Second Revision No. 1-NFPA 289-2022 [Section No. 5.5.1]

Second Revision No. 3-NFPA 289-2022 [Section No. 7.4.2.1.2]

Second Revision No. 2-NFPA 289-2022 [Section No. C.1.2.2]

Figure 7.4.2.1.2 Bidirectional Probe.

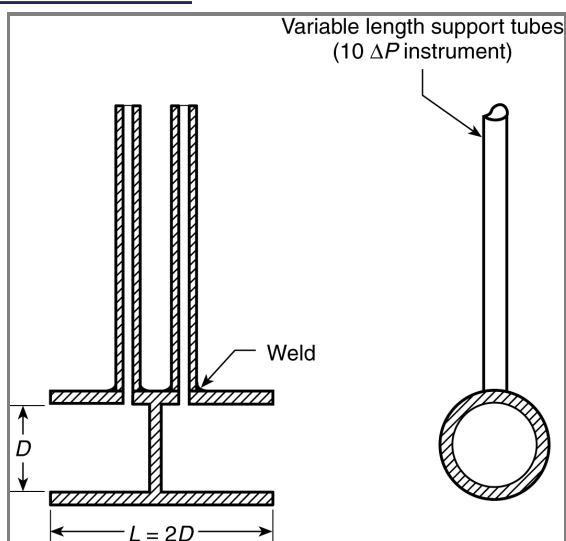
7.4.2.1.2

A typical probe, as shown in Figure 7.4.2.1.2, shall consist of a stainless steel cylinder that is $44 \text{ mm} \pm 1 \text{ mm}$ ($1.75 \text{ in.} \pm 0.040 \text{ in.}$) long and $22 \text{ mm} \pm 1 \text{ mm}$ ($0.875 \text{ in.} \pm 0.040 \text{ in.}$) inside diameter with length L , inside diameter D , and a solid diaphragm in the center.

Committee Statement: Adding a bidirectional probe figure as is shown in other FIZ documents to this section. The same figure was revised in multiple documents this cycle. This is related to CI-2.
